TECHNICAL BULLETIN

K407NAS1

Service Action: AWD V6 Petrol S/C Cross Brace Foul

XE (X760)

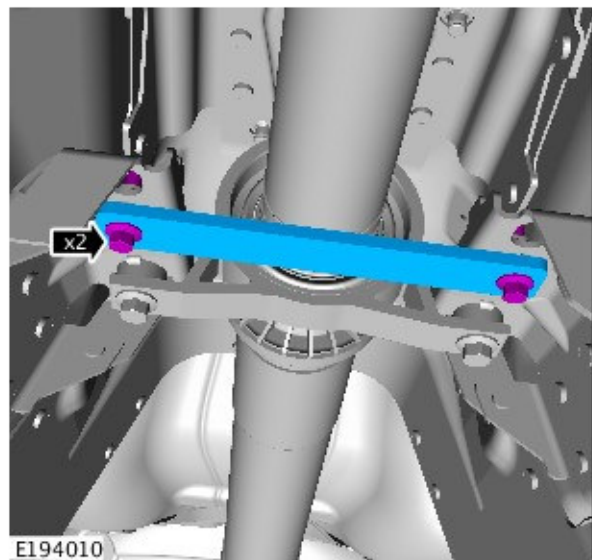
3. Remove the cross brace and fixings.

4. Inspect the driveshaft for signs of damage in the area the cross brace was installed.

- If the driveshaft has signs of damage, continue to Step 5.
- If the driveshaft has no signs of damage, discard the cross brace and fixings.
- Continue to Step 6.

E194840

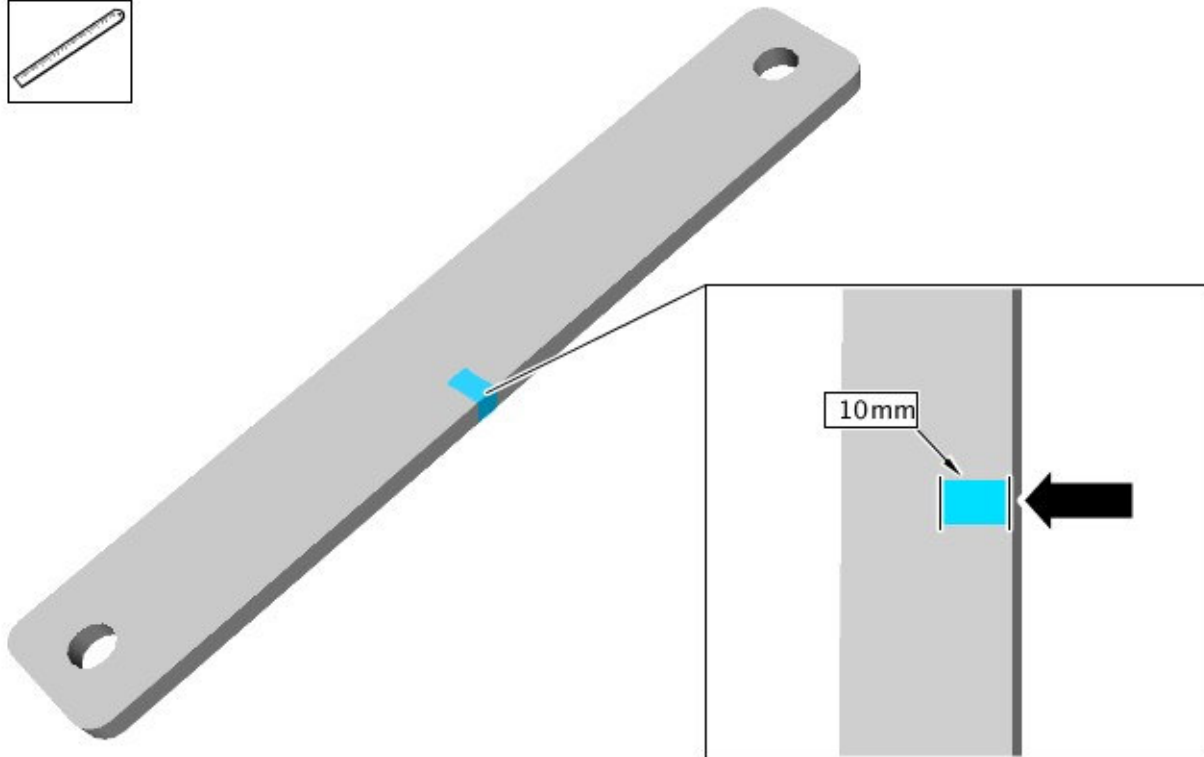
5.  **NOTE: If the contact damaged length is more than 10mm, submit an Electronic Product Quality Report (EPQR), including a picture of the cross brace damage.**

Inspect the cross brace contact damaged length.

- If the contact damaged length is less than 10mm, discard the cross brace, clean the damaged area on the driveshaft, and paint with Rust-Oleum High Heat Black (248903).
 - Continue to Step 6.
- If the contact damaged length is more than 10mm, discard the cross brace, install a new driveshaft (see TOPIx Workshop Manual section 205-01: Driveshaft), and release the vehicle.
 - Submit an Electronic Product Quality Report (EPQR), including a picture of the cross brace damage.
